**AMENDMENTS TO THE DRAWINGS:**

## REMARKS

Application No. 10/813,610  
Reply to Office Action Dated 09/20/05  
ANNOTATED SHEET

Fig. 7

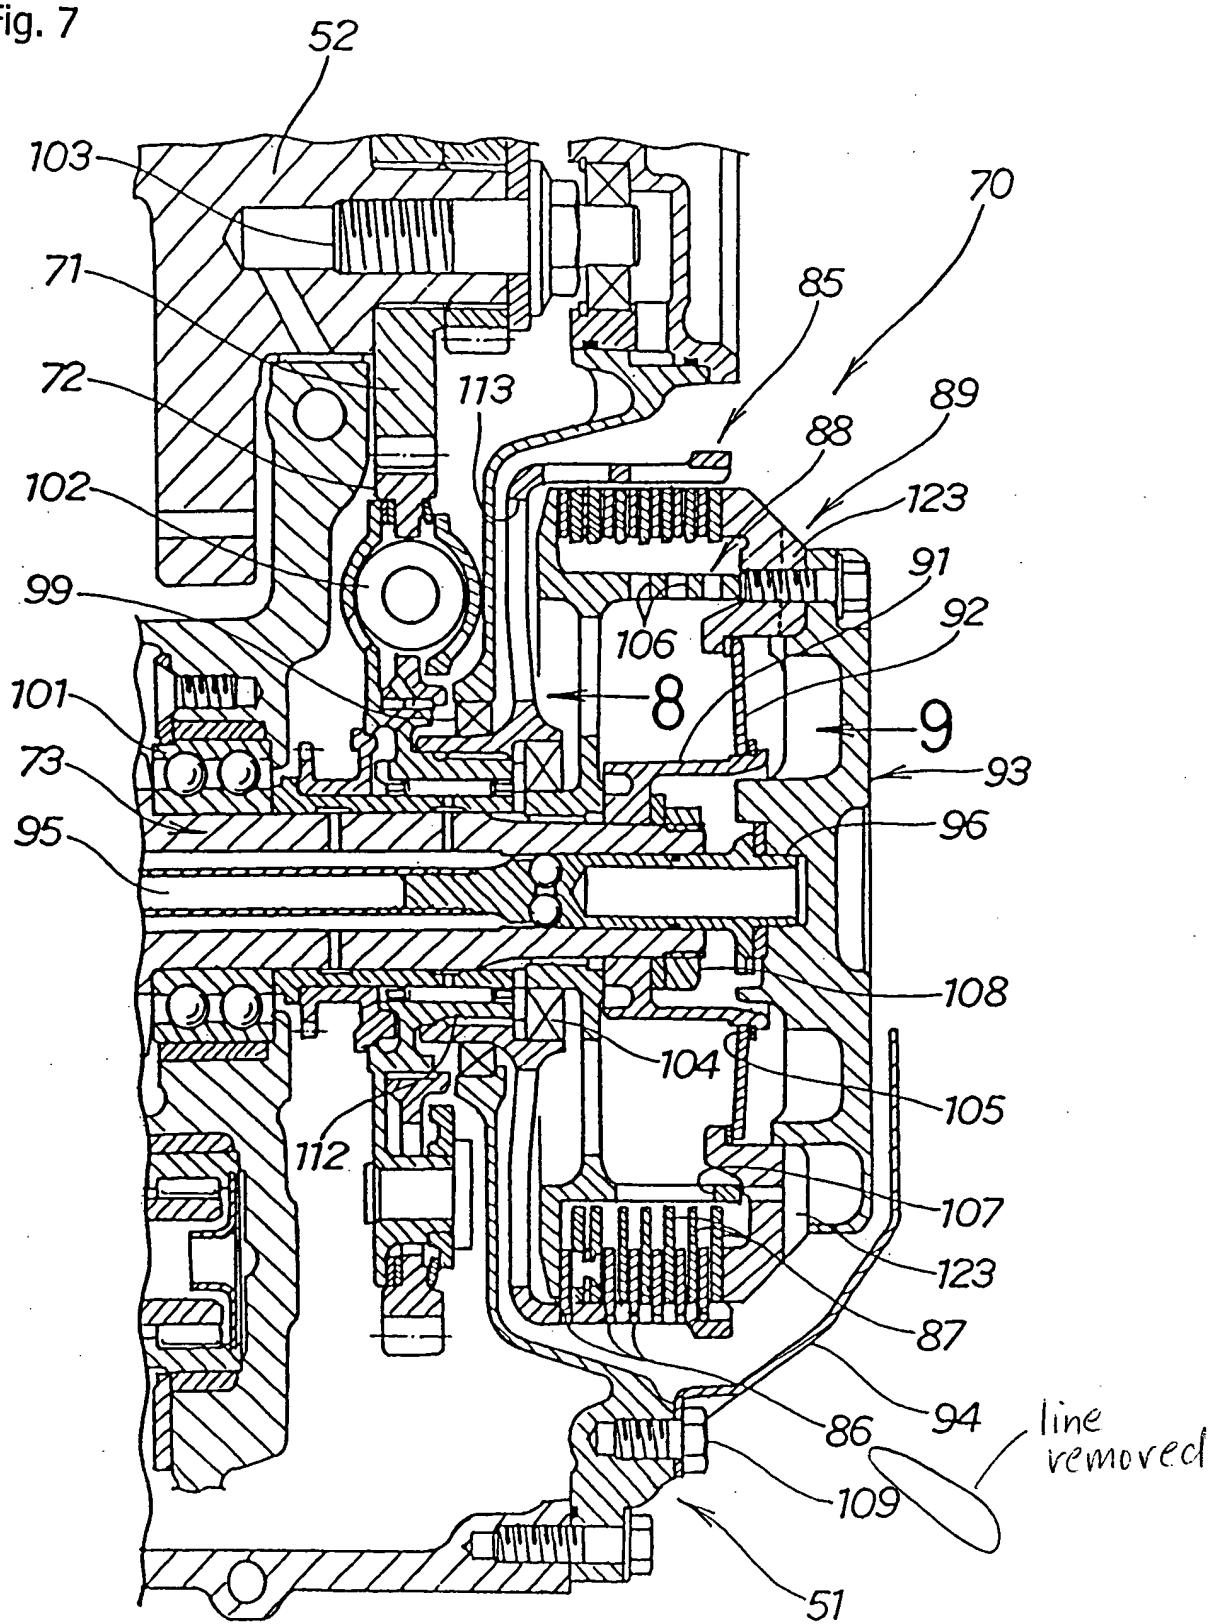
7. In Fig. 7, an extraneous line has been removed.

Fig. 9

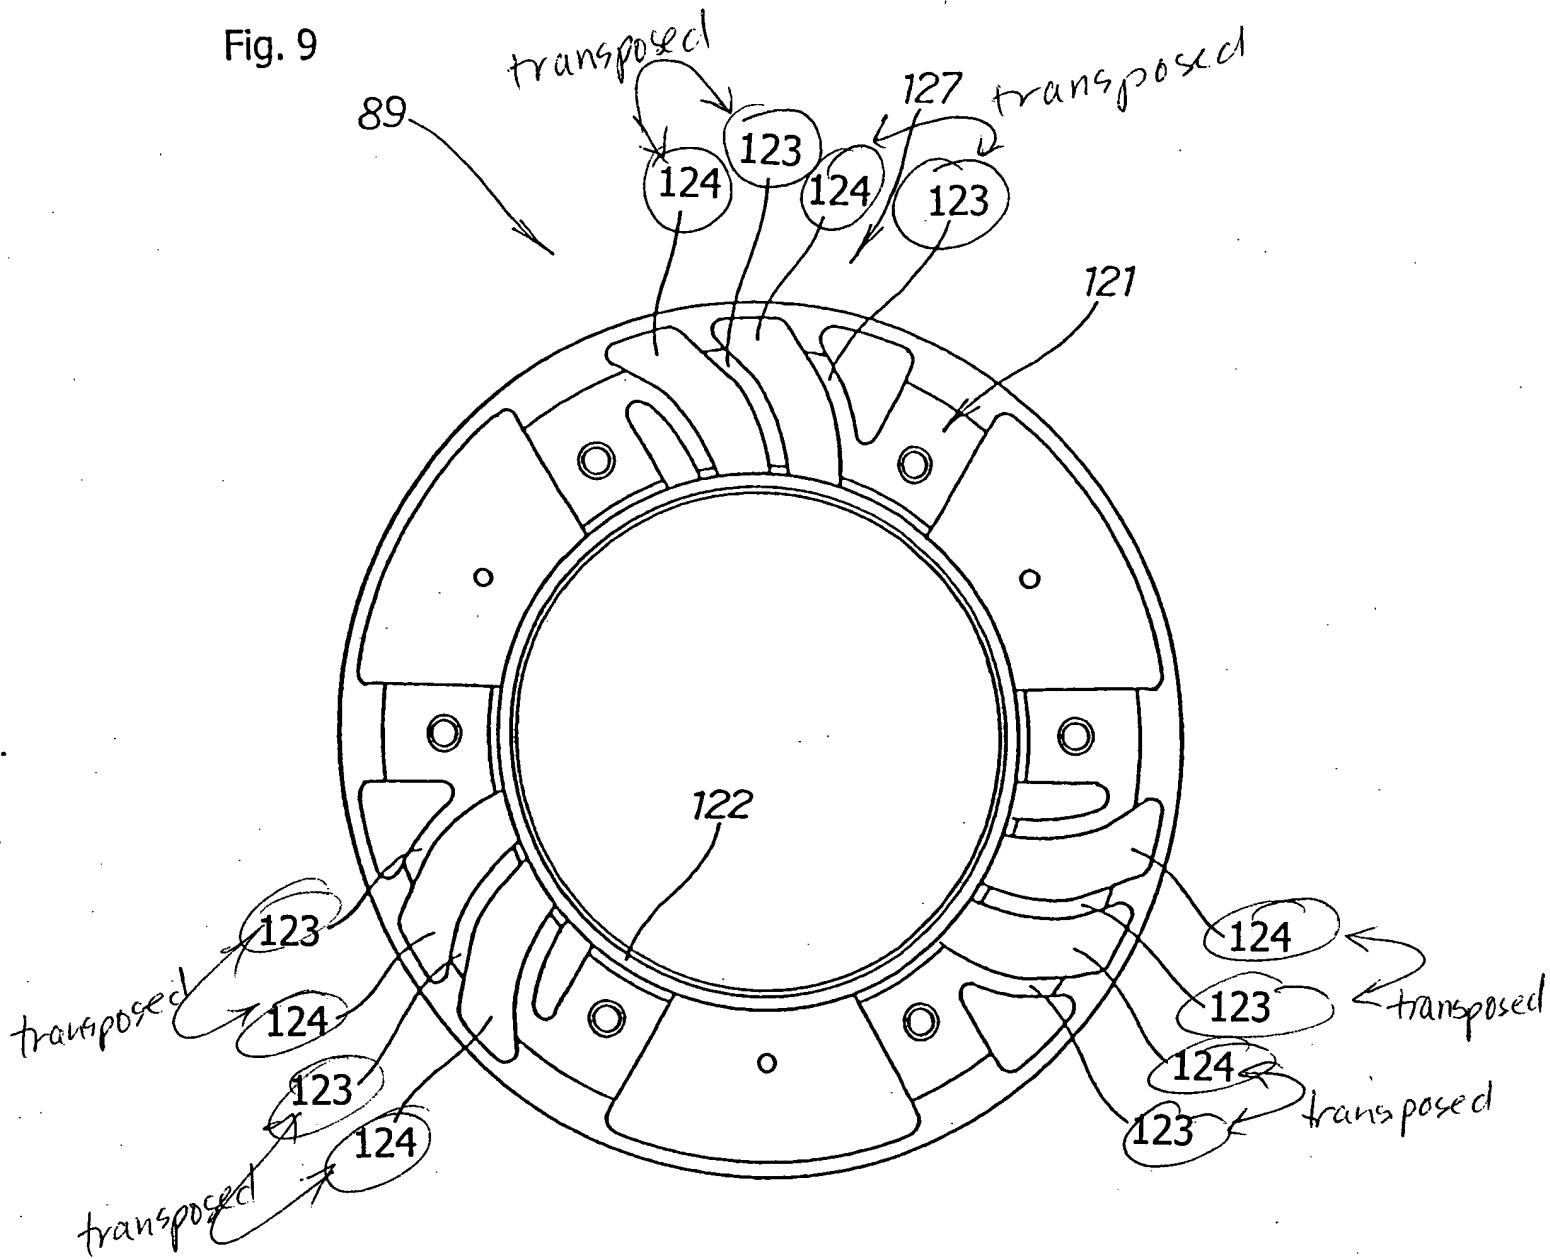
9. In Fig. 9, previously transposed reference numbers 123 and 124 have been corrected, so that reference number 123 indicates a passage and reference number 124 indicates a fin. This correction permits Fig. 9 to be consistent with the written description.

Fig. 11

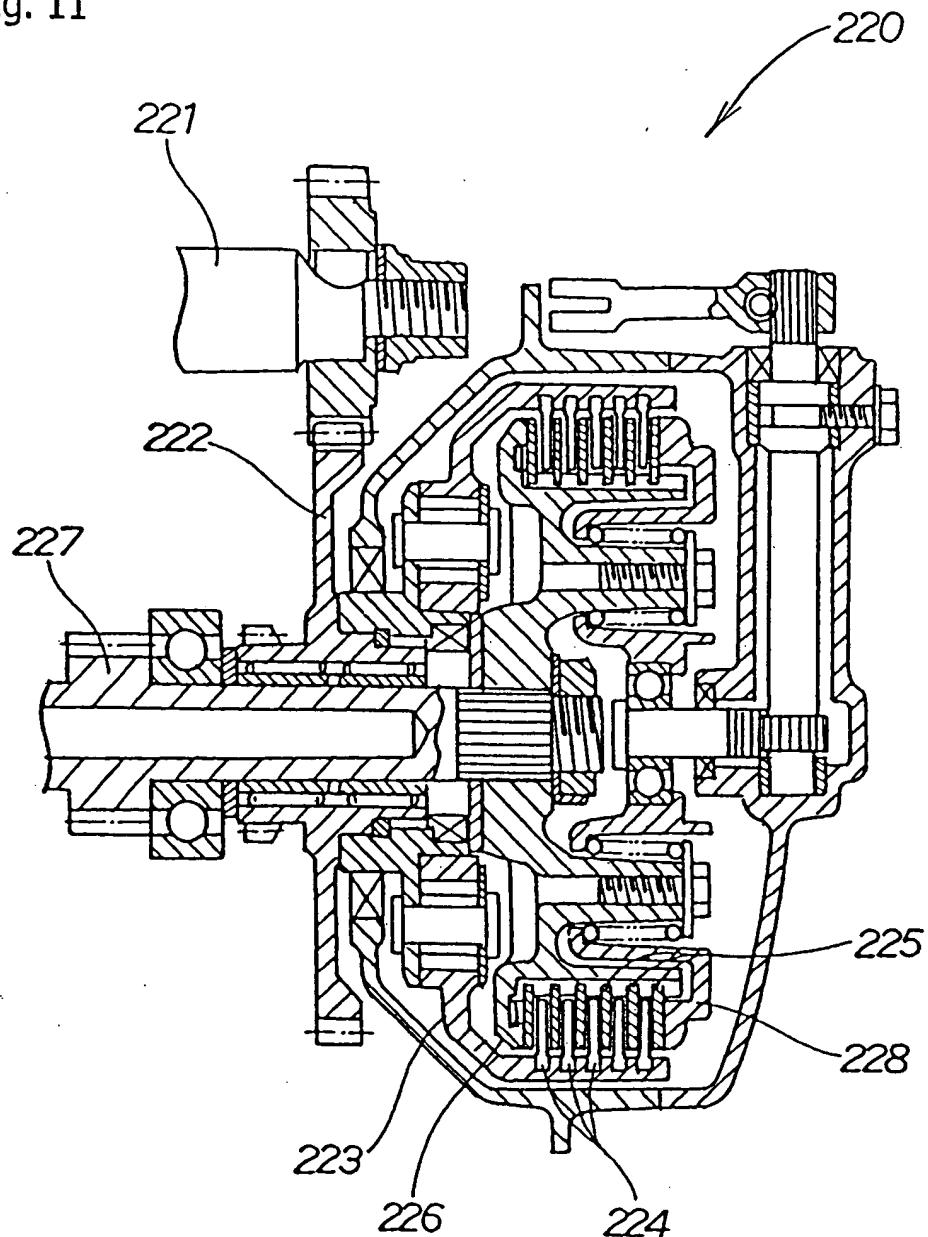
11. In Fig. 11, the figure label "PRIOR ART" has been added.

Previously omitted label is added.
